ROAD DESIGN DETAIL	REVISION	
	12	04-21-20
	531-02	
SHEET 1 of 1

**MEDIAN CROSSOVER AT INTERCHANGE
(50' MEDIAN)**

SECTION A-A

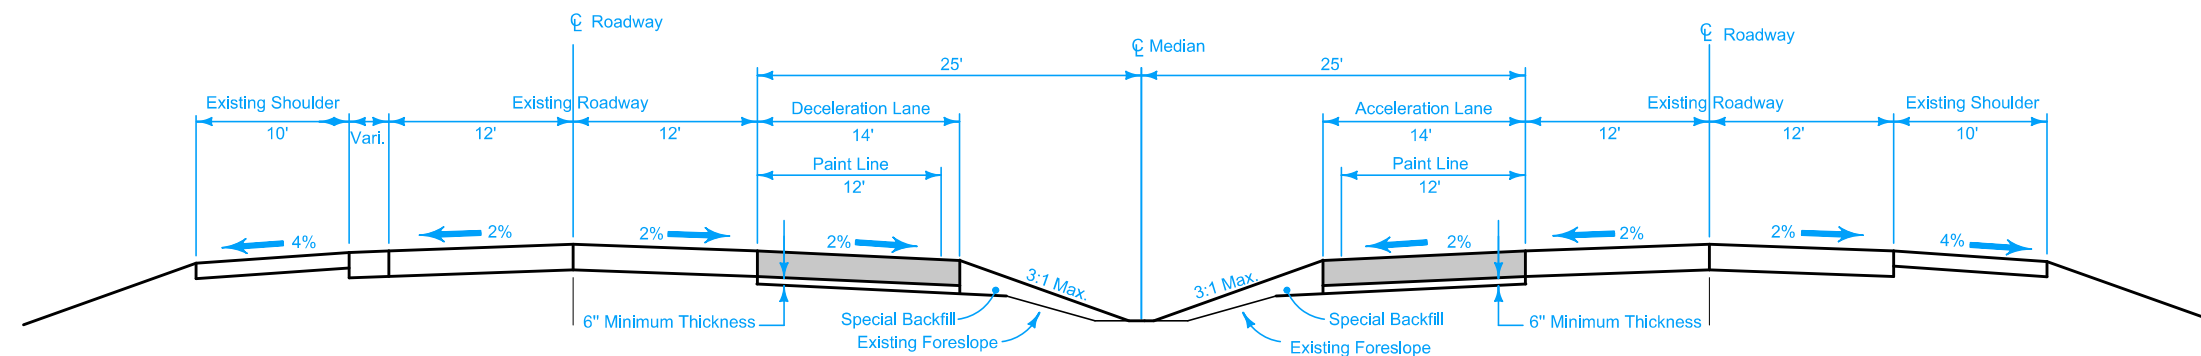
REVISIONS: Added reference to DR-502 for slotted drain. Replaced Section A-A and deleted Section B-B.
